From: [REDACTED]
Sent: 18 June 2020 17:10
To: [REDACTED]
Cc: [REDACTED]
Subject: RE: 20200618-Little Rissington ATZ Proposal Feedback

From: [REDACTED]
Sent: 18 June 2020 10:23
To: [REDACTED]
Cc: [REDACTED]
Subject: 20200618-Little Rissington ATZ Proposal Feedback

Thank you for sight of the attached Little Rissington ATZ proposal and the opportunity to provide comment. My comments are as below, in capacity as Head of Training/Flight Examiner RAF Brize Norton Flying Club and the RAUWG rep for 6 Air Experience Flight/Oxford UAS RAF Benson. I do not formally represent RAF Brize Norton who provide their RAUWG representation through SATCO.

AEF/UAS Tutor Operations

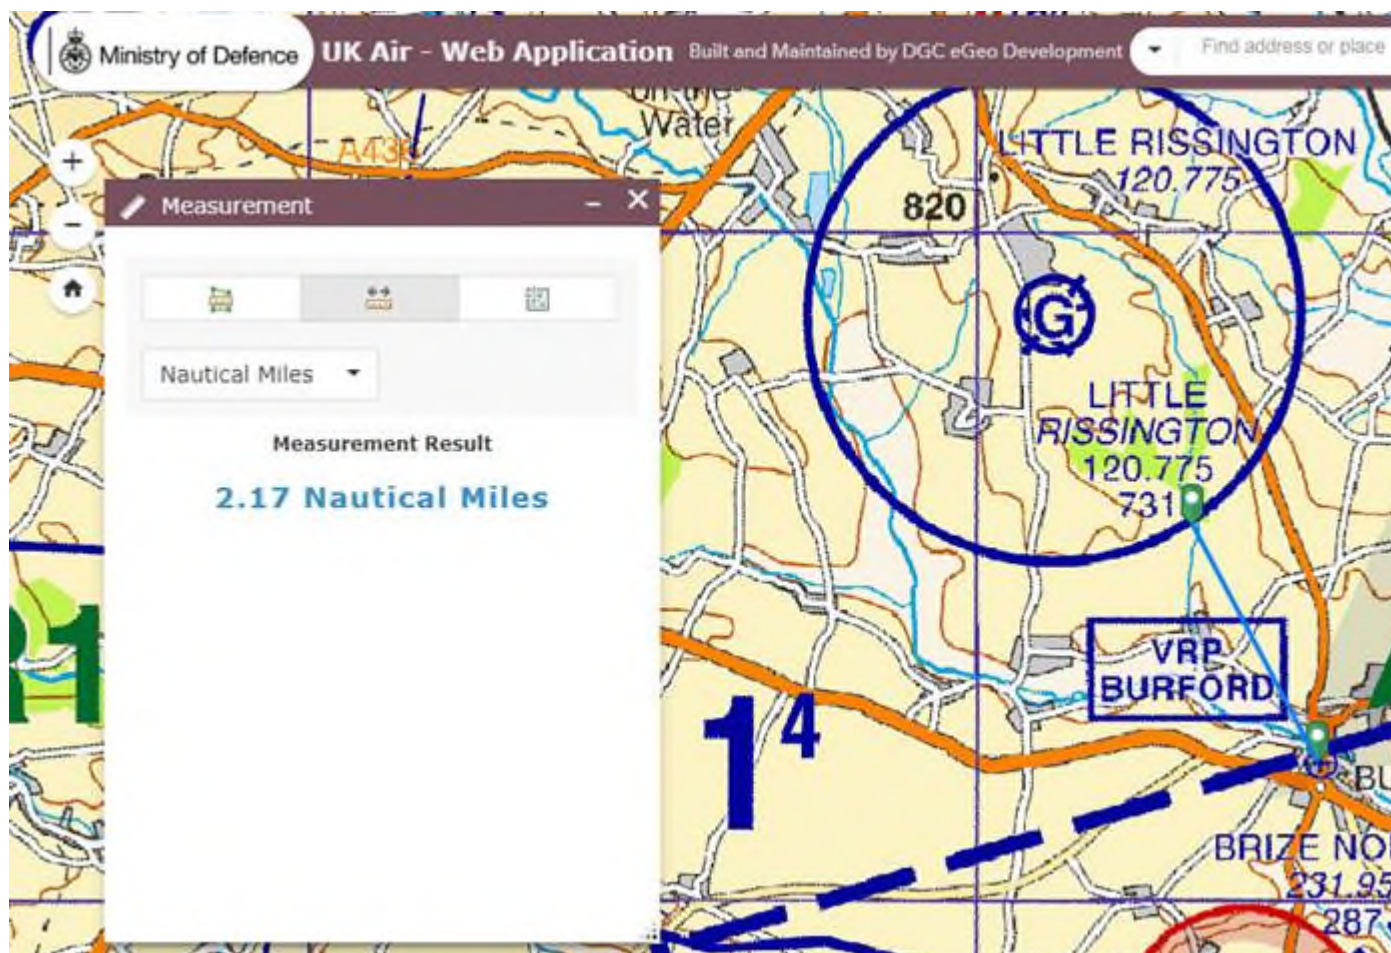
6 AEF Tutors would rarely operate to the North of Brize Zone due to the transit time and limited sortie duration of AEF flights. UAS and AEF/UAS SCT flights may utilise the area to North of Brize for training to seek clear airspace away from the congested ‘Vale’ area to the South of Brize, but these flights are generally weekdays when your ATZ would not be active. In the event of ATZ activation and Tutors operating in the Brize North area, Tutors would be working Brize freqs and are likely to be significantly higher than 2000’ AAL for GH.
